**PLANNED UNIT DEVELOPMENT
& SUBDIVISION STAFF REPORT****Date: January 17, 2008**

<u>DEVELOPMENT NAME</u>	Revised Hillcrest Trace Subdivision, Resubdivision of Lot 12
<u>SUBDIVISION NAME</u>	Revised Hillcrest Trace Subdivision, Resubdivision of Lot 12
<u>LOCATION</u>	Southeast corner of Hillcrest Road and Hillcrest Trace Drive
<u>CITY COUNCIL DISTRICT</u>	District 6
<u>AREA OF PROPERTY</u>	1 Lot/ 0.2+ Acres
<u>CONTEMPLATED USE</u>	Planned Unit Development Approval to amend a previously approved Planned Unit Development to allow a further reduced side street setback, and Subdivision approval for 1 lot.
<u>TIME SCHEDULE FOR DEVELOPMENT</u>	Immediate
<u>ENGINEERING COMMENTS</u>	Must comply with all storm water and flood control ordinances. Any work performed in the right of way will require a right of way permit.
<u>TRAFFIC ENGINEERING COMMENTS</u>	Driveway number, size, location, and design to be approved by Traffic Engineering and conform to AASHTO standards.
<u>URBAN FORESTRY COMMENTS</u>	Property to be developed in compliance with state and local laws that pertain to tree preservation and protection on both city and private properties (State Act 61-929 and City Code Chapters 57 a

SITE PLAN

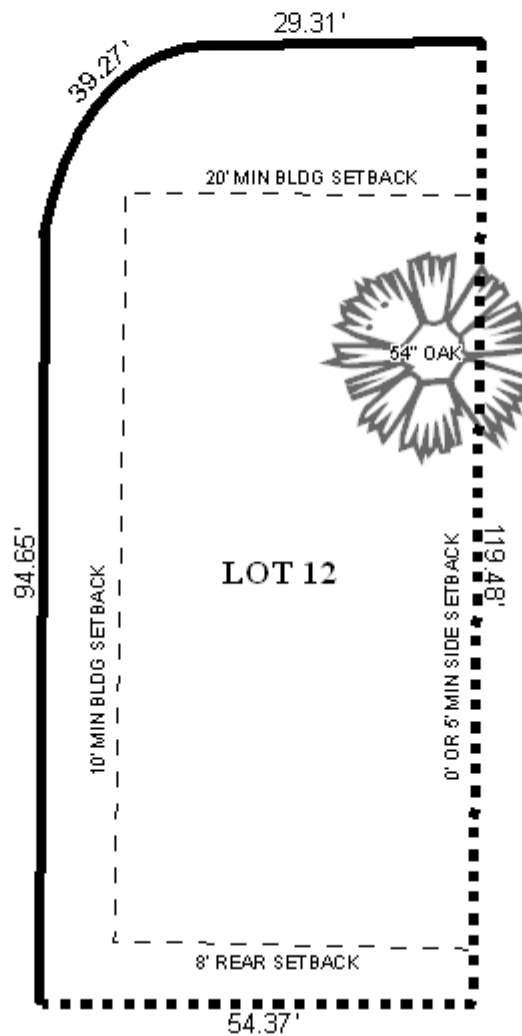
The applicant is seeking Planned Unit Development approval to amend a previously approved Planned Unit Development to allow the street side setback to be reduced from 20-feet to 10-feet in a zero-lot line single-family residential subdivision, and Subdivision approval. The site is located in Council District 6 and served by public water and sanitary sewer.

Regarding the proposed building setbacks, 20-feet is proposed for the front yard setback, while 10-feet is proposed as the street-side side yard setback. As a 20-foot side yard setback for corner lots is allowed by the Zoning Ordinance, but not by the Subdivision Regulations, the Subdivision Regulation requirements should not be waived in favor of the requested setbacks. The corner lot side-yard setback should remain as approved due to proximity to Hillcrest Road, a major street. It should be noted that Lot 1, directly across from the site has complied with the 20-foot setback along Hillcrest Road.

Subdivision: Based upon the preceding, this application is recommended for denial.

Planned Unit Development: Based upon the preceding, this application is recommended for denial.
